CHANGE BULLETIN 02 **F.G.A. No. 21003**

ROOMS TO GO – OFFICE RENOVATION & EXPANSION
Seffner, Florida

February 8, 2022

FIRST FLOOR REFLECTED CEILING PLAN E 1
1/8" = 1'-0"

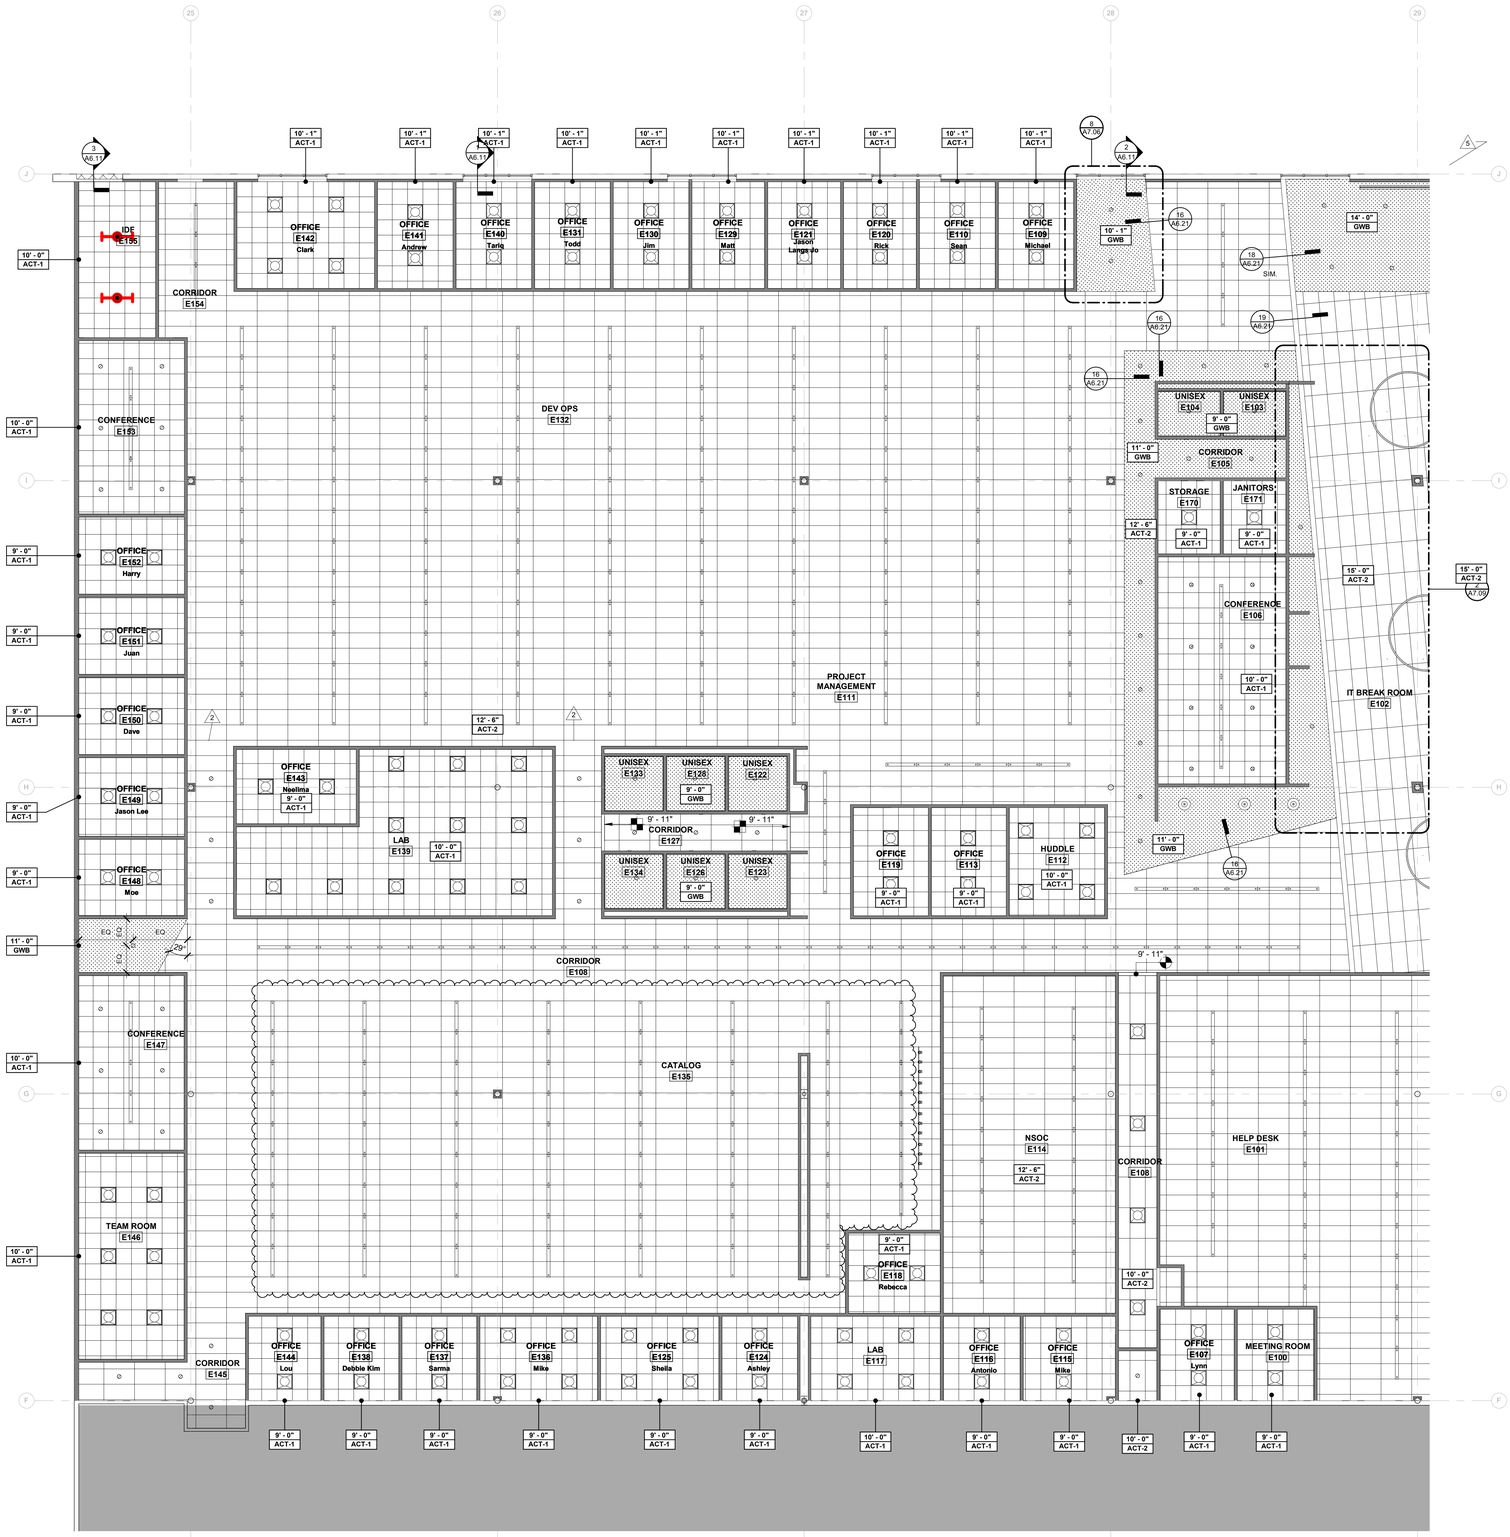
Item 15: Refer to Sheet A8.01E – Reflected Ceiling Plan E
ADJUST pendant fixtures to avoid conflict with wall.

HVAC PLAN - B
1/8" = 1'-0"

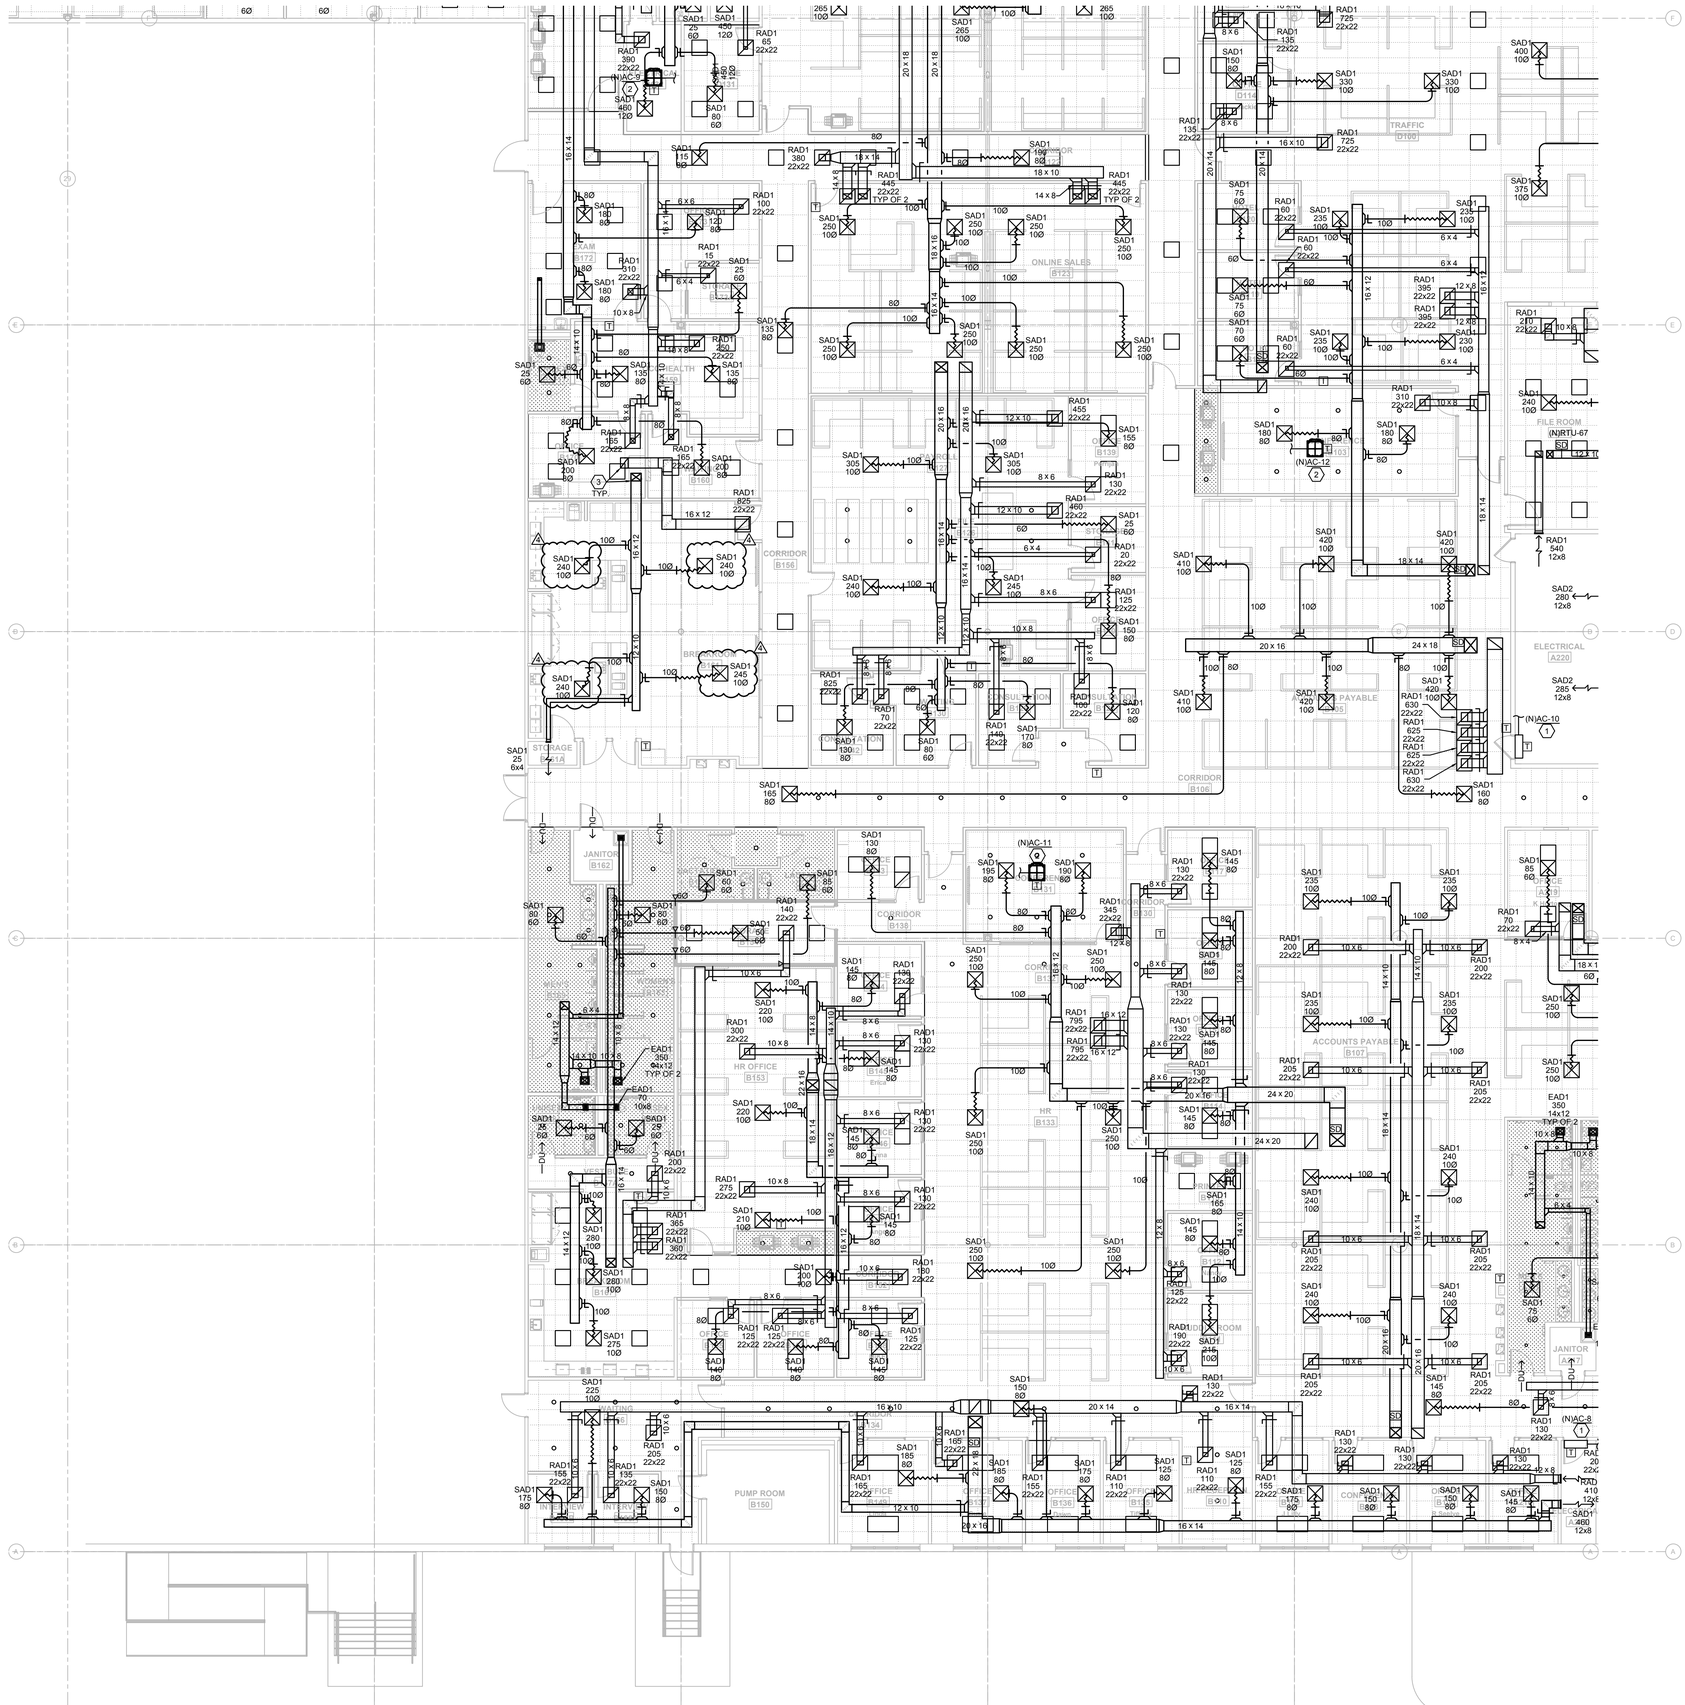
Dwg No	Description	Remarks
M1.10B	HVAC PLAN - B	• Shifted diffusers to match new ceiling grid in room 161
M1.10E	HVAC PLAN – E	• Shifted diffusers to avoid clashes with electrical light fixtures in area 135.

DEMOLITION PLUMBING PLAN - B
1/8" = 1'-0"

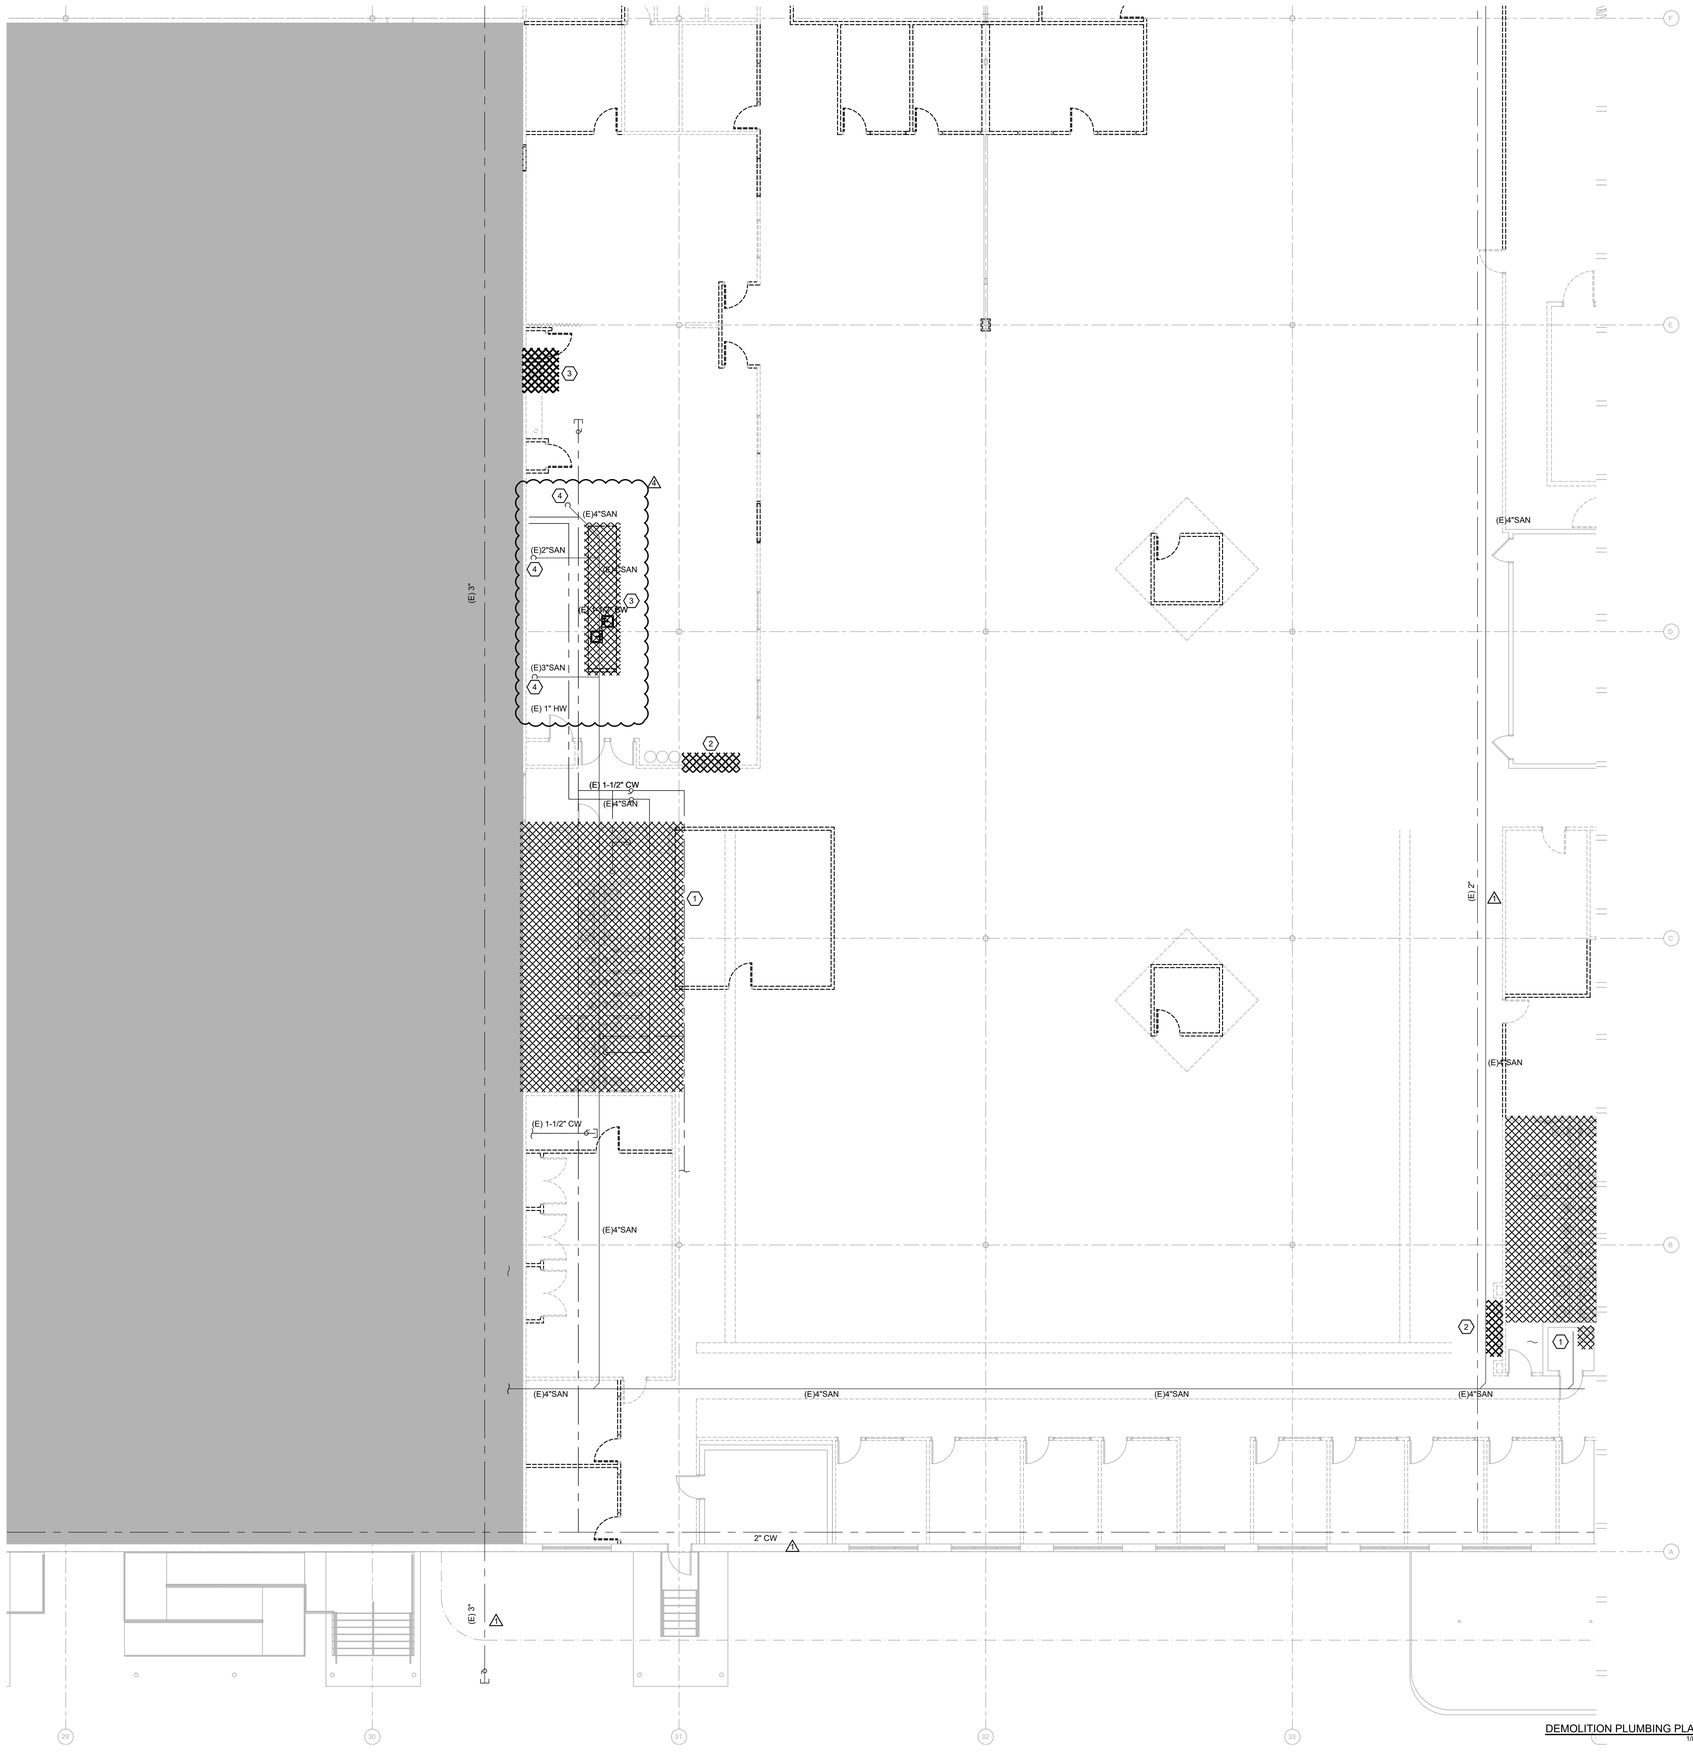
Dwg No	Description	Remarks
PD1.10B	DEMOLITION PLUMBING PLAN – B	• Added demolition scope for new breakroom B161. • Added and revised existing sanitary piping in breakroom b161.

POWER PLAN - E
1/8" = 1'-0" 1

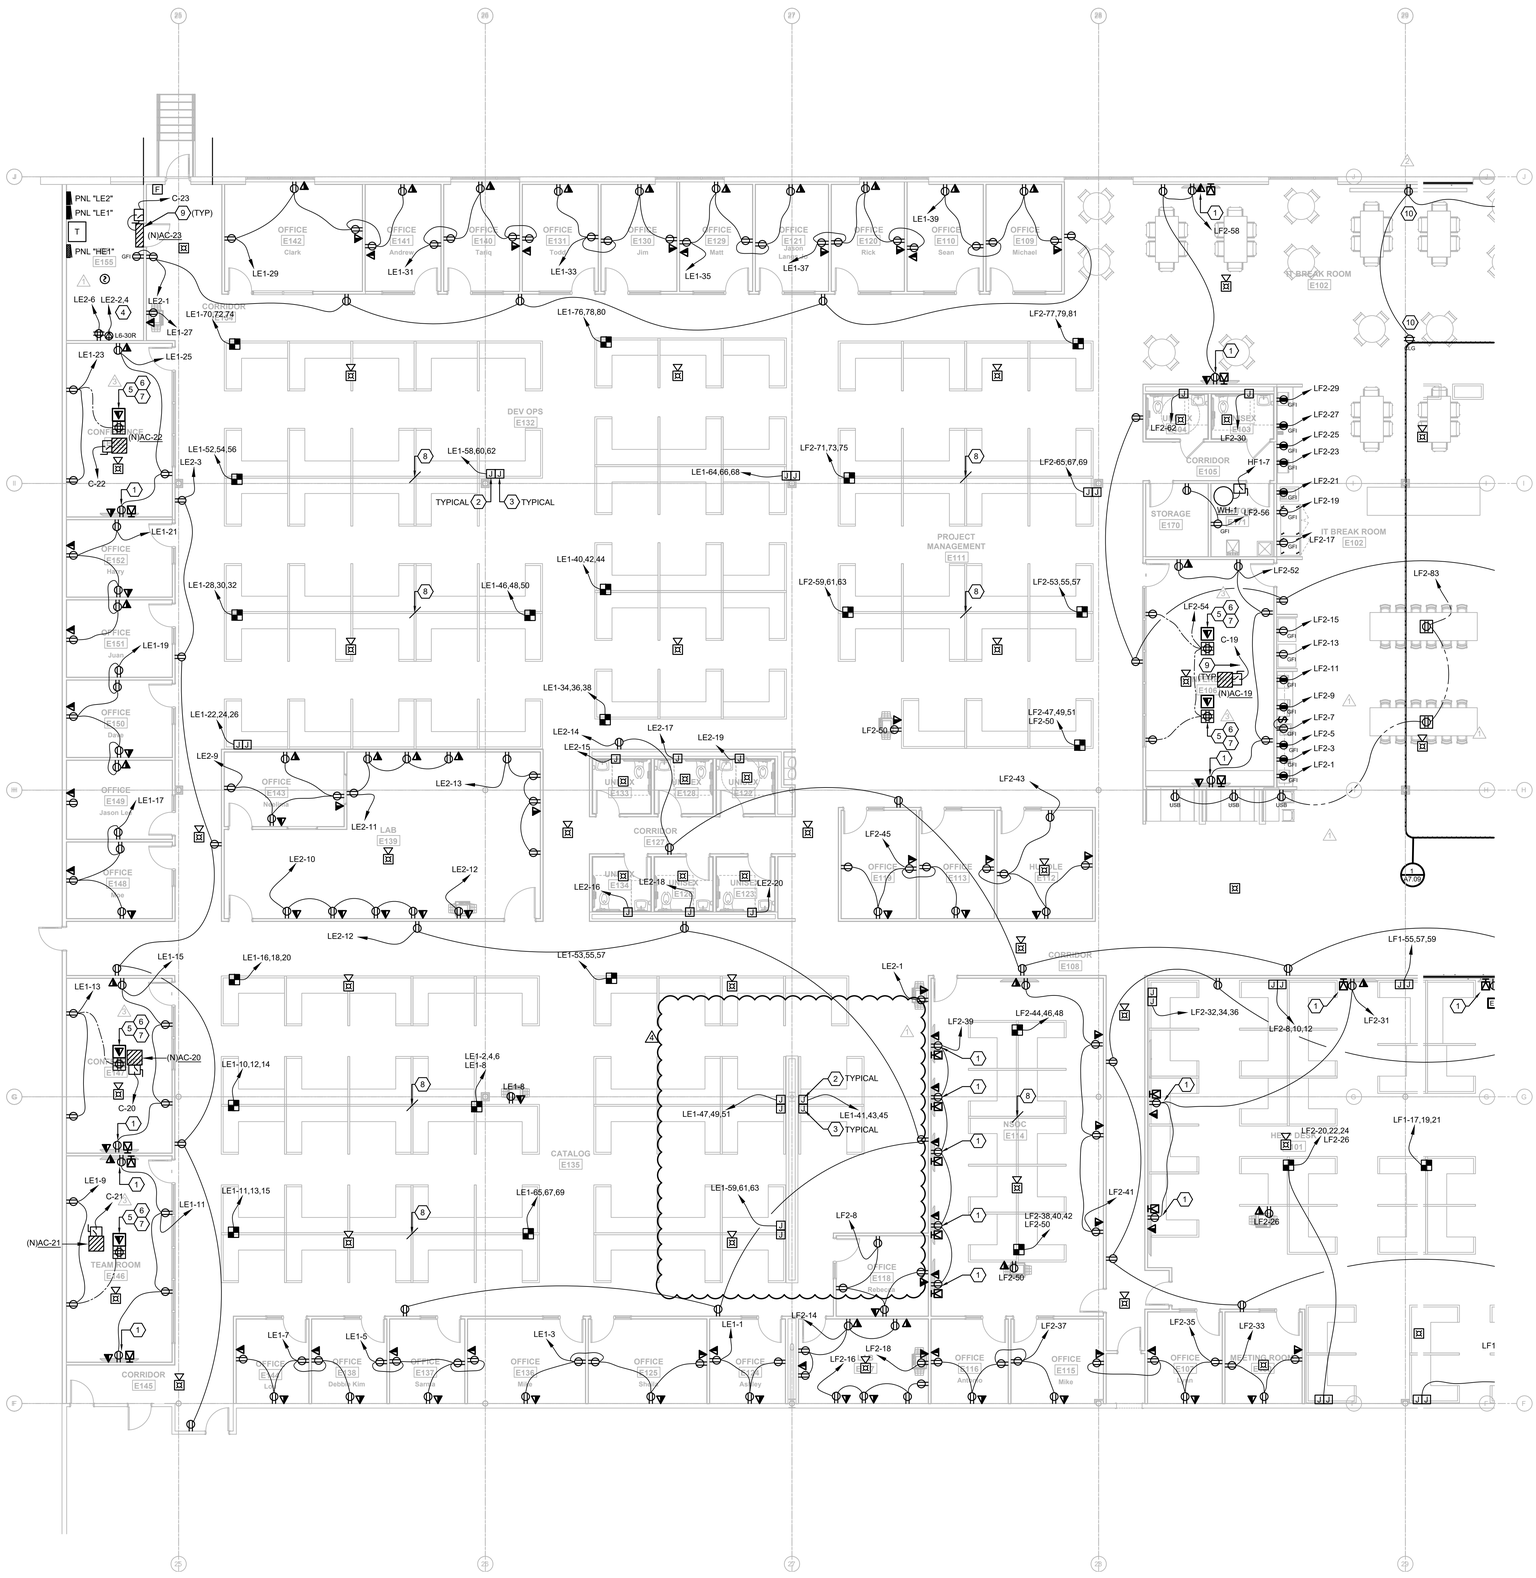
Dwg No	Description	Remarks
ED1.10B	DEMOLITION PLAN – B	• Added demolition scope for new breakroom B161.
E1.10B	POWER PLAN – B	• Added power for additional scope added in breakroom B161.
E1.10E	POWER PLAN – E	• Revised furniture feeds to wall fed versus power pole.
E2.10B	LIGHTING PLAN – B	• Revised lighting in breakroom B161.
E2.10C	LIGHTING PLAN – C	• Revised lighting in executive area C105.
E2.10E	LIGHTING PLAN – E	• Shifted linear rows to work with wall wrap around existing columns.
E6.01	ELECTRICAL SCHEDULES - SERVICE ONE	• Revised panel schedules LCC1 and LCC2.
